INDESIT company

BAN13VXFR

F047640

Technical Documentation guidelines

N1030093fig1

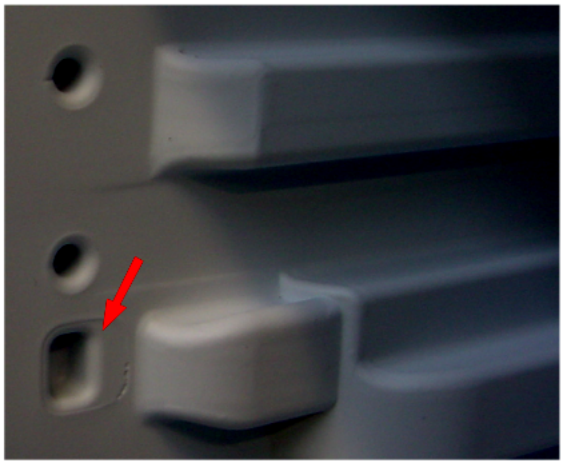
n1030093: New fixing of evaporator on static fridge-freezers (05 range) 60 cm,Melano

From August 05 (serial no. 50802.0001) the freezer evaporator is secured to the cabinet by a plastic profile.
The cabinet walls have been modified to create locations to house the profile, which is installed on the front of each evaporator plate (see photo N1030093fig1- fig2 - fig3)
The profile cannot be fitted on premodification appliances, so technical personnel must continue to fit the rh and lh supports on these models (see photo N1030093fig4)

New parts
C00141135 = WHITE PROFILE L=443.5 MM

Parts replaced
C00075596 = EVAPORATOR RH SUPPORT
C00075597 = EVAPORATOR LH SUPPORT
